TOYOTA

EG-0008T-01 12

Technical Service Bulletin

Subject: 1KD-FTV engine: piston crack	Engine
Models: HILUX; LAND CRUISER	
Model codes: KUN26; KDJ120; KDJ125; KDJ150; KDJ155

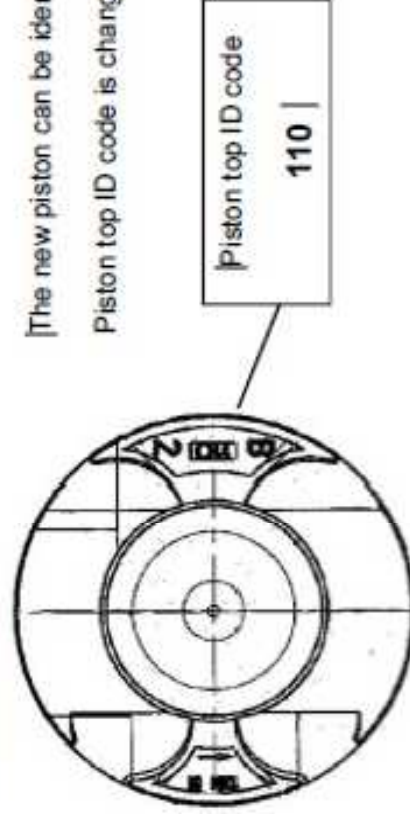
[The new piston can be identified by the piston top ID code.

Piston top ID code is changed from 080 to 110 |

It is advised to confirm the piston top ID code upon arrival of the new parts. If an older version of pistons is installed, replace them by new ones.
